Details of the proposed variation to the action

“DP Green Energy Pty Ltd (100% owned by the DP Energy Group of companies) propose to develop a wind farm (the Project) in the Calliope Range, approximately 75 km west-south-west of Gladstone in Central Queensland and within the Banana Shire local government area. The Project would comprise of the installation of around 70 wind turbines with a capacity of approximately 420MW of electricity supplied to the national electricity grid.”

Attachment A - Referred project design (2021)

Attachment B - Revised project design (2022)

Table 1 provides a summary of design changes between the referred design and the current, detailed design. Refer to Attachments A and B for a comparison of the project design from the original referral with the current, variation design.

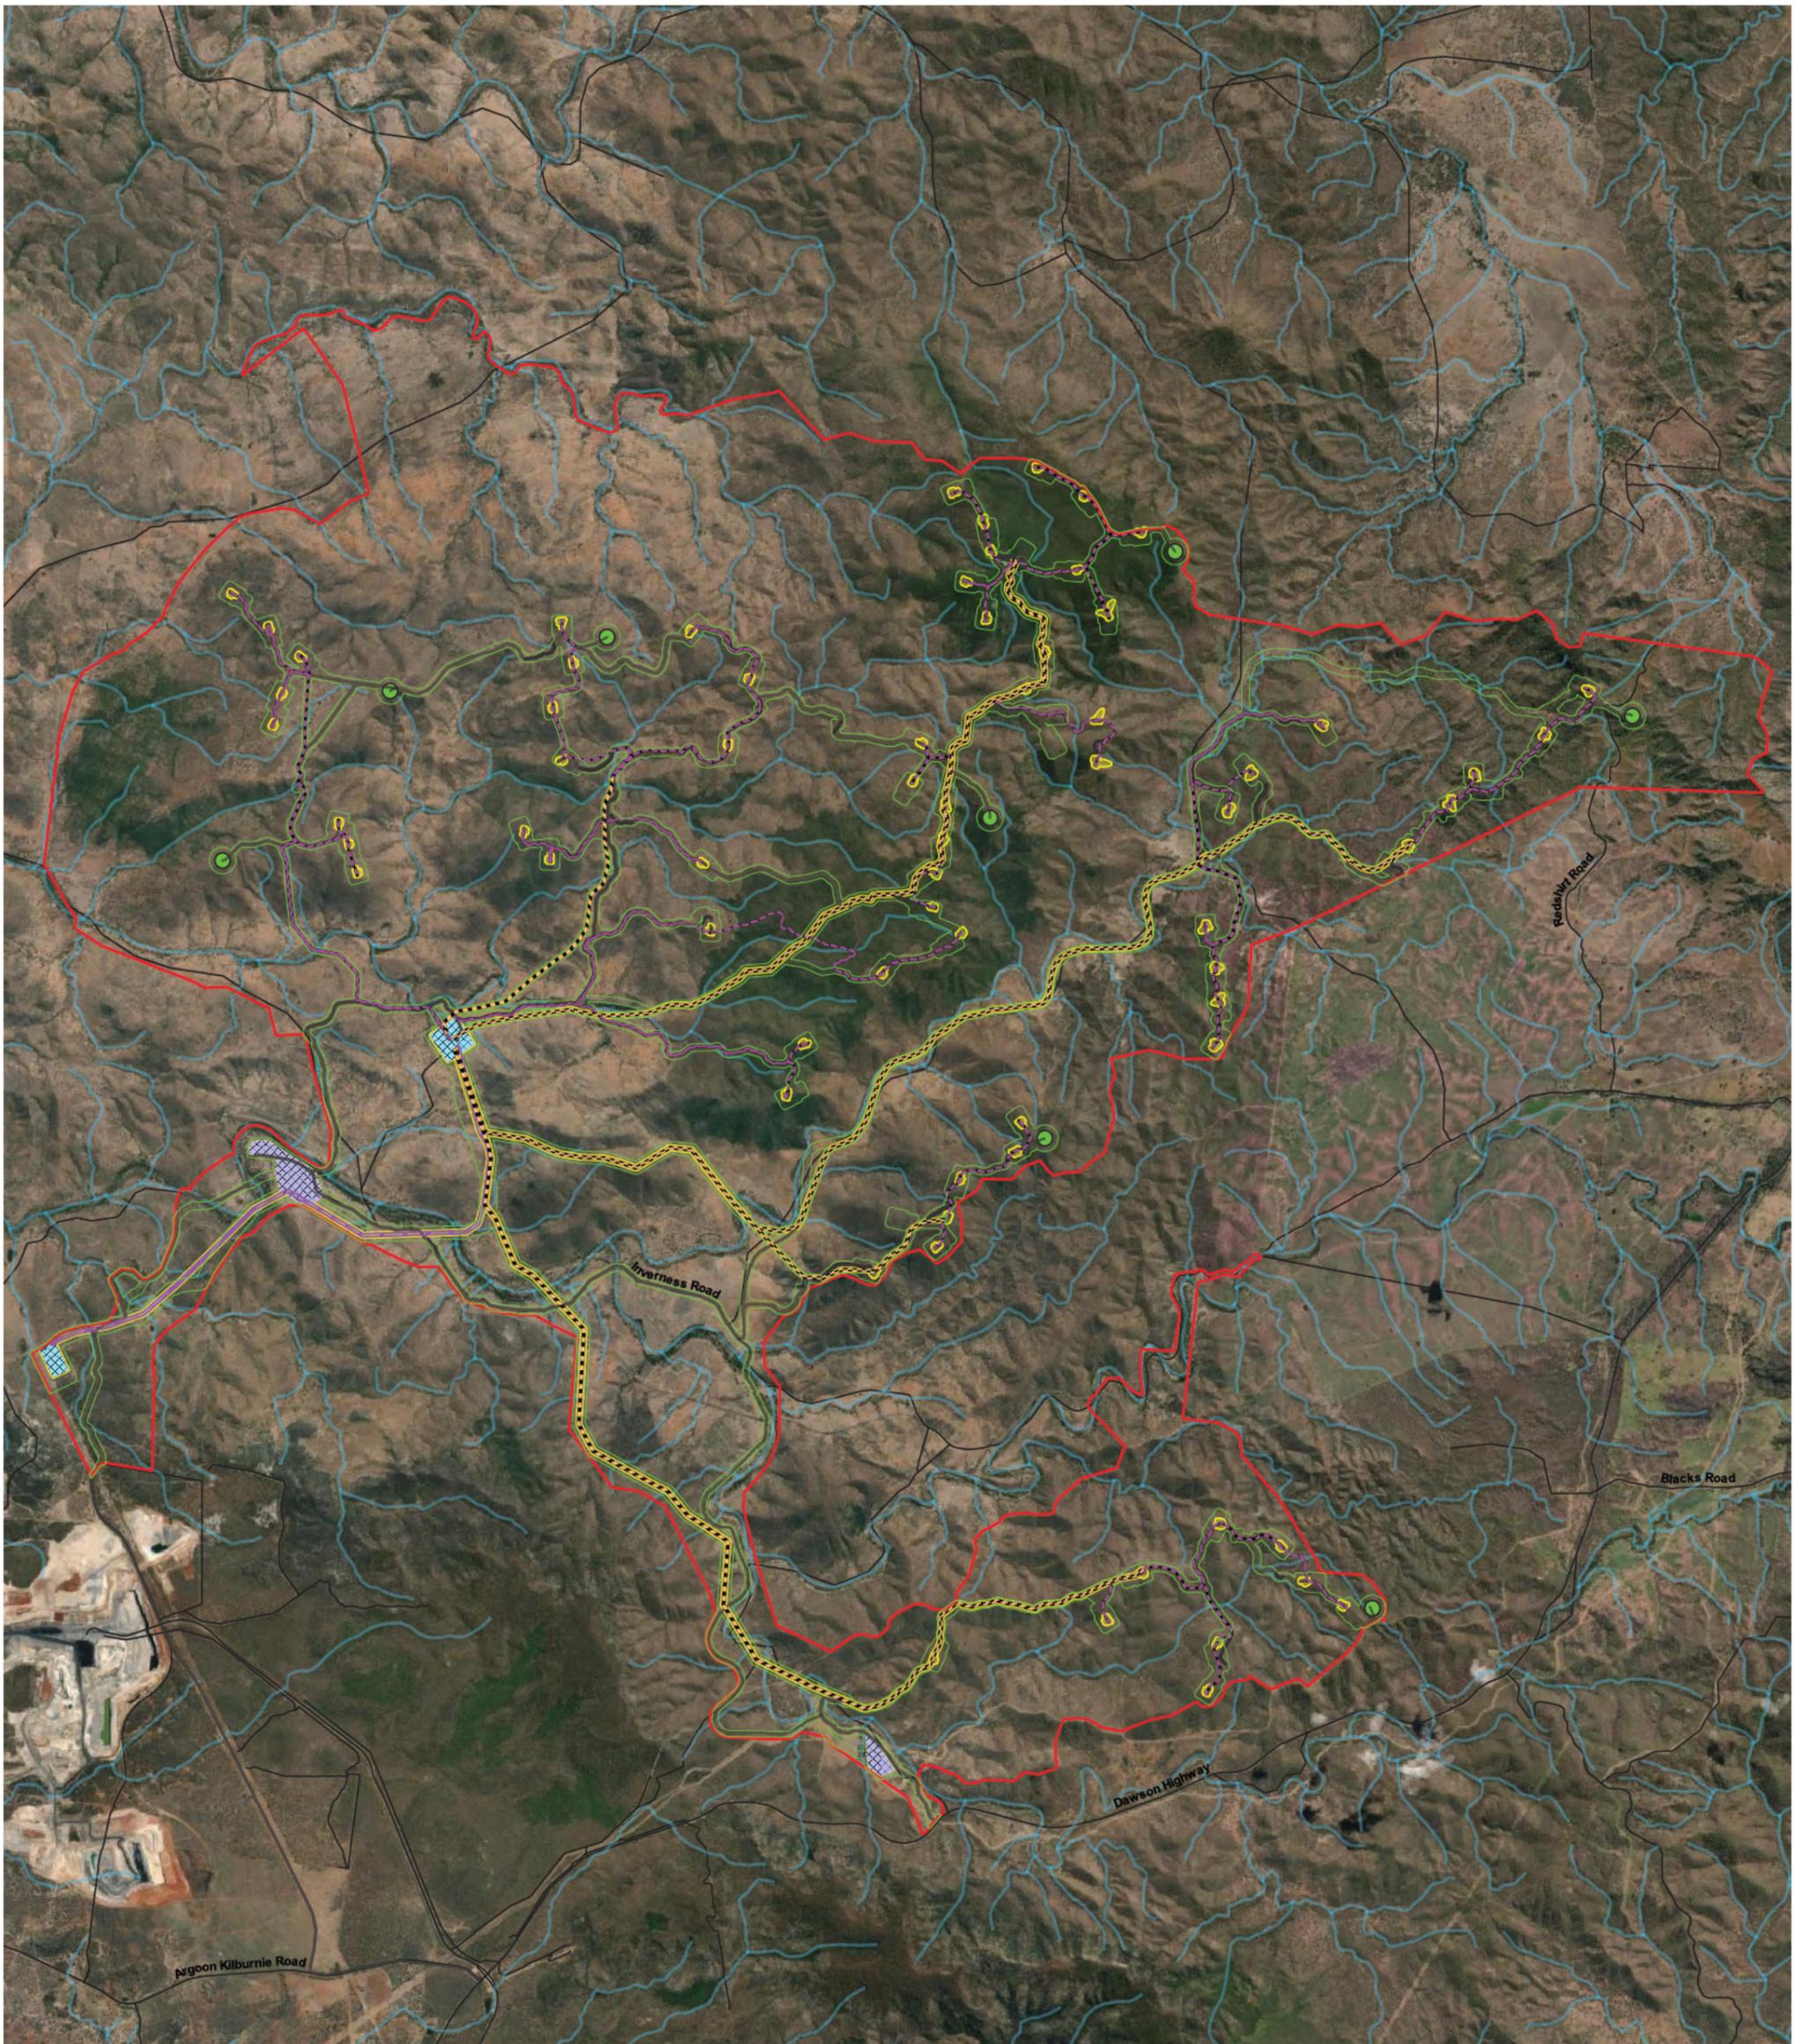
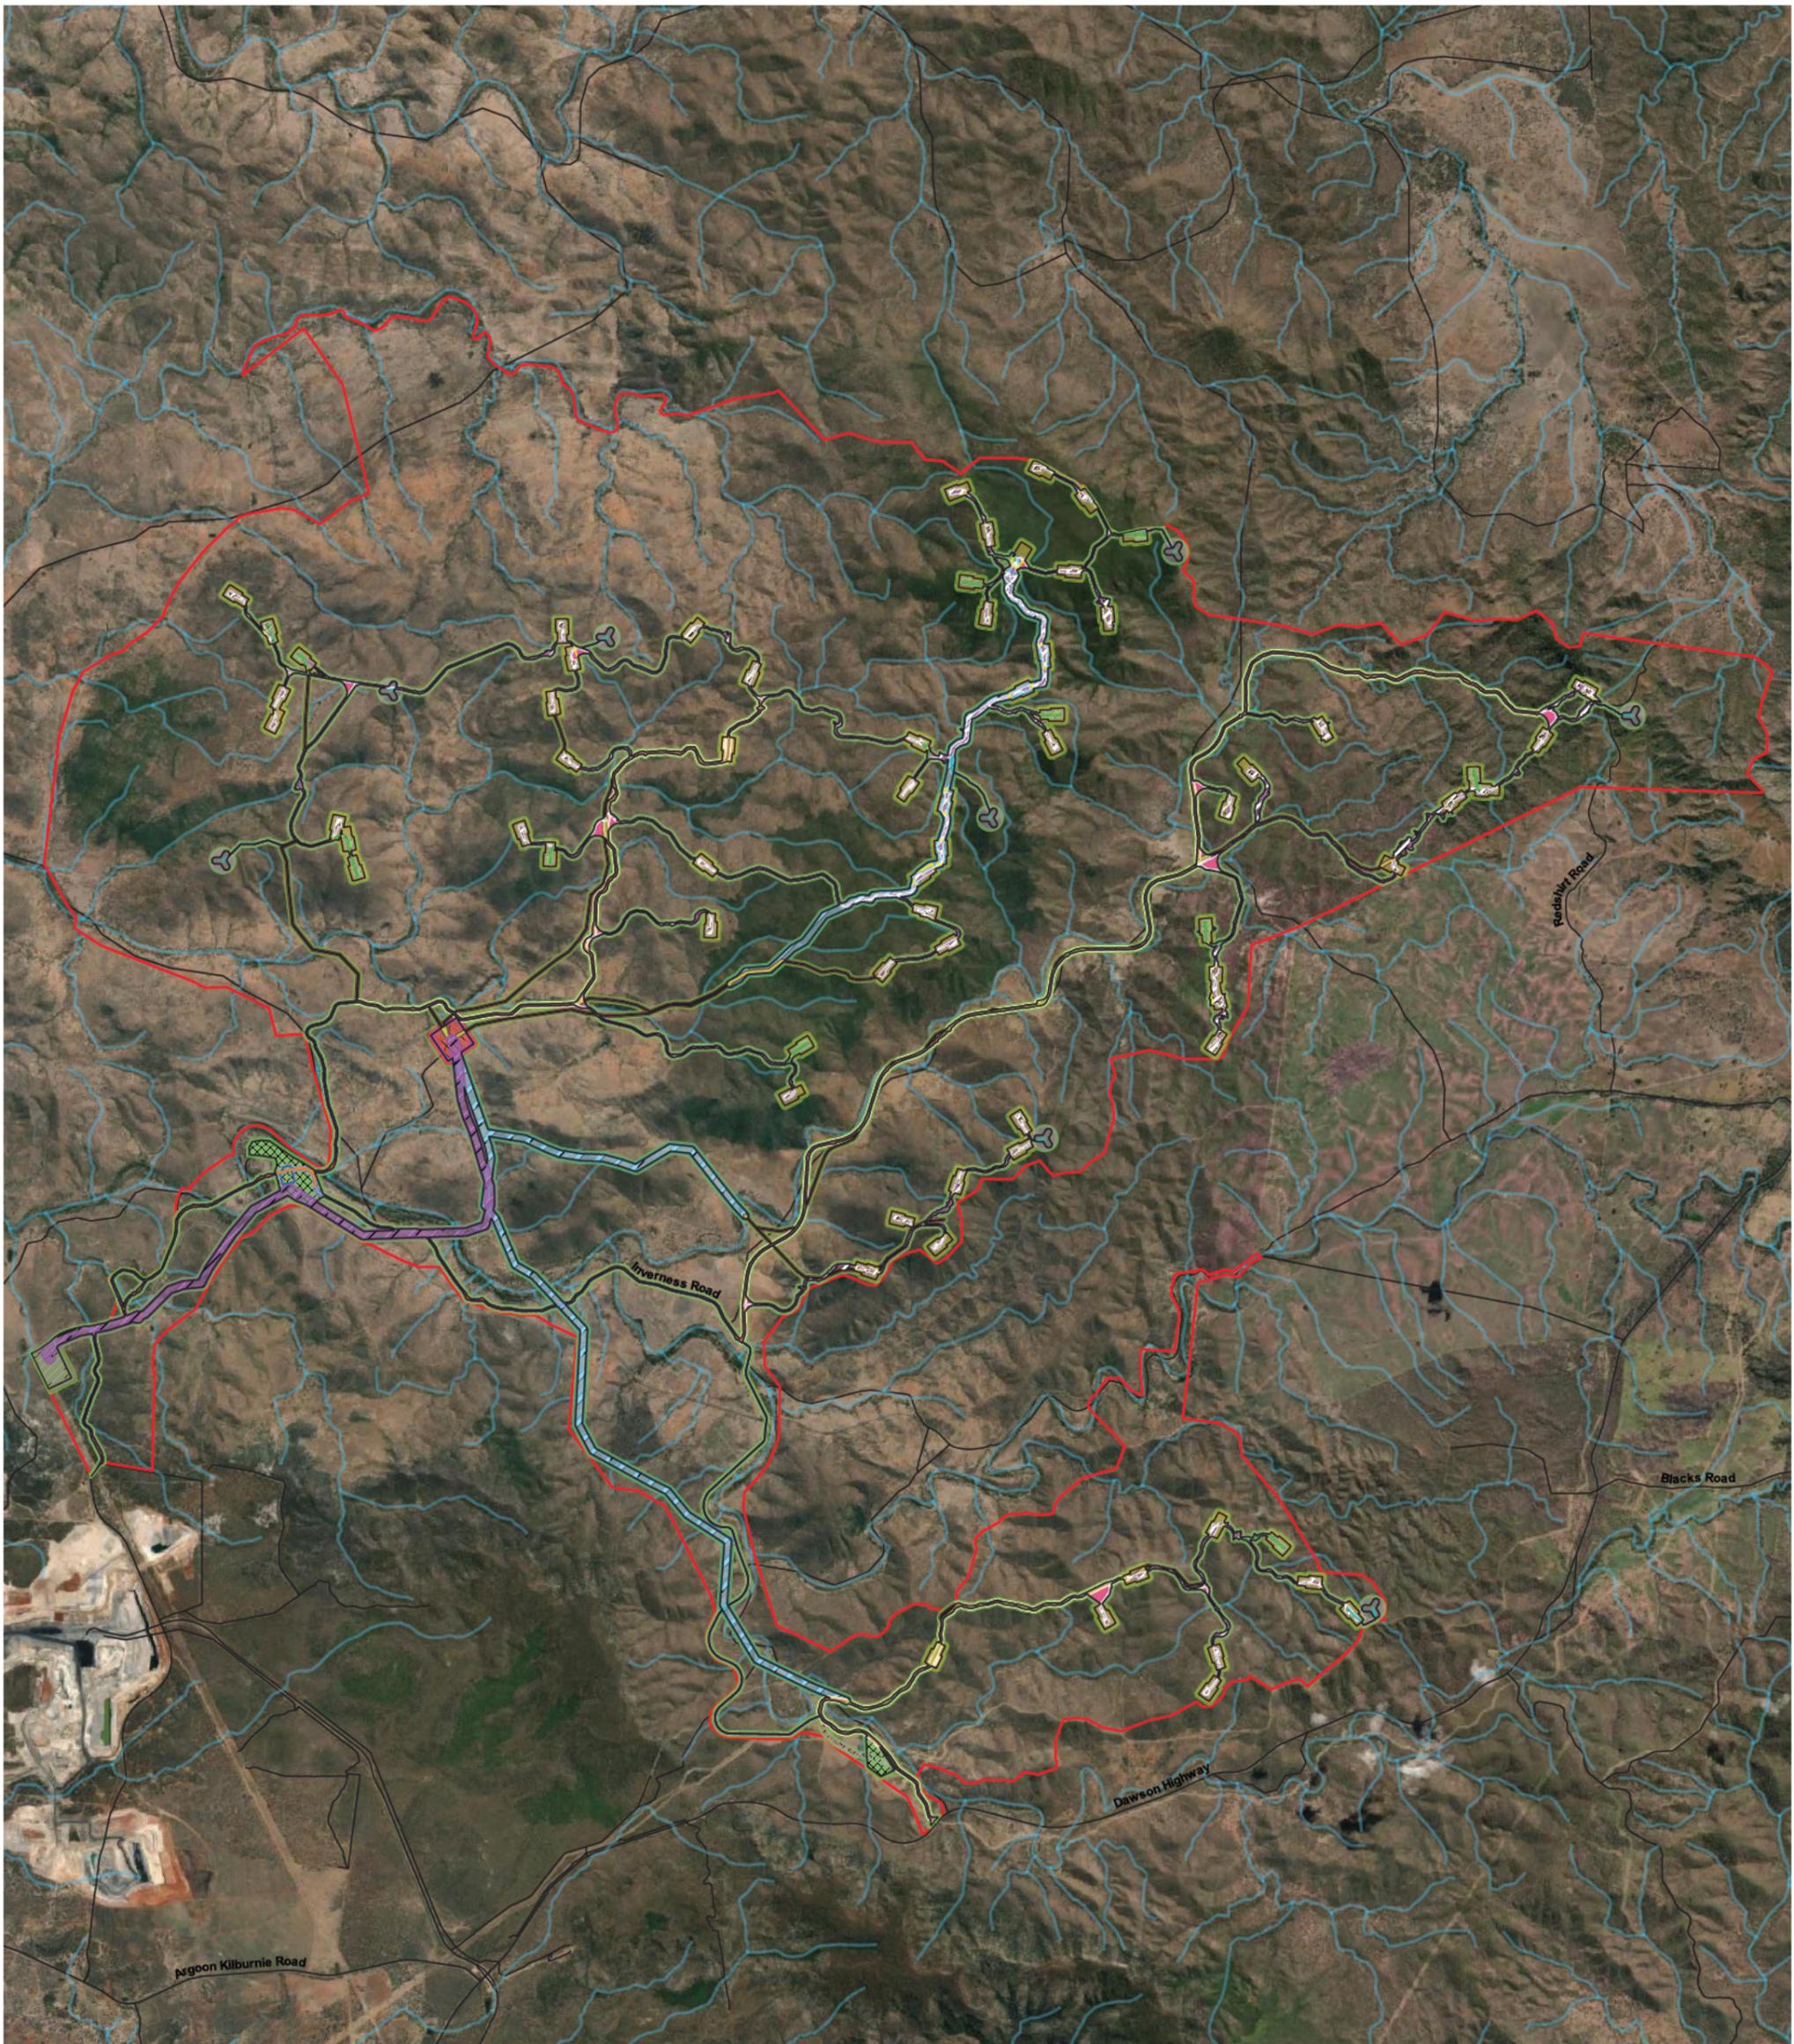
1. The project design has been further developed and refined, increasing the megawatts (MW) of supplied electricity from approximately 420MW to a maximum installed capacity of 462MW (noting that the number of turbines proposed has not increased, only the electrical output of each turbine) and strategically locating the site office, site substation and switching station, underground cabling, overhead connections, track network, turbines and temporary construction compound in response to additional ecological information.

2. A Project Area has been introduced into the Project design. The Project Area is a micro-siting corridor surrounding the Development Footprint within which all development (and impacts) will occur, and within which the Development Footprint can be moved during detailed design, to allow for micro-siting.

These changes have resulted in an increase to the Development Footprint from 895.5ha to 1,023.19ha, an increase of 127.69ha. This is the maximum area of impact and the reason for this application to vary the action.

The proposed variation is for an increase to the Development Footprint from 895.5ha to 1023.19ha. There is no proposed change to the project description, no increase in the number of wind turbines, a reduction in tracks from 168km to 124km and a reduction in overhead cabling from 52km to 25km.

The reason for this increase is to allow for micro-siting and to respond to site conditions, including the presence of ecological values such as *C. megacarpa* and hollow-bearing trees which may provide denning habitat for Greater Glider. The Development Footprint will be micro-sited within the Project Area where possible to avoid impacts to MNES habitat. If you have any questions, please contact me, [REDACTED] on the below, or alternatively [REDACTED] (General Manager Biodiversity) on [REDACTED]. We would be pleased to discuss any aspect of the variation with you further.
